Grassy Lake Rd west of Jack Pine St

ADA Grade Issue at existing crosswalk

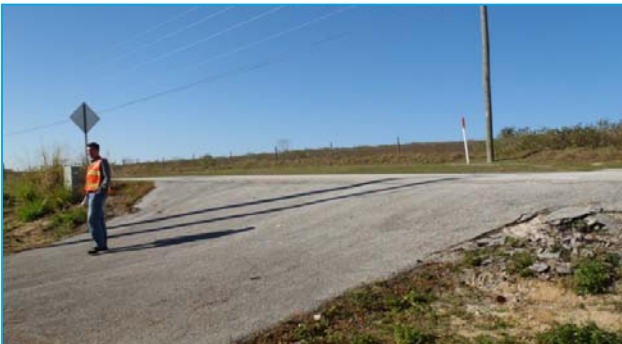
- ✓ Crosswalk facilitates shift of sidewalk from north side to south side of roadway
- ✓ Crosswalk connects to existing utilities access driveway with significant grade (does not meet ADA)
- ✓ Sidewalk connecting to driveway is covered with sand/debris
- ✓ Crosswalk does not have any lighting

- ✓ Shift midblock crosswalk further east to avoid ADA/grade issue
- ✓ Add lighting so crosswalk is well lit
- ✓ Add advance yield lines (30 ft separation) & yield here to pedestrians signs
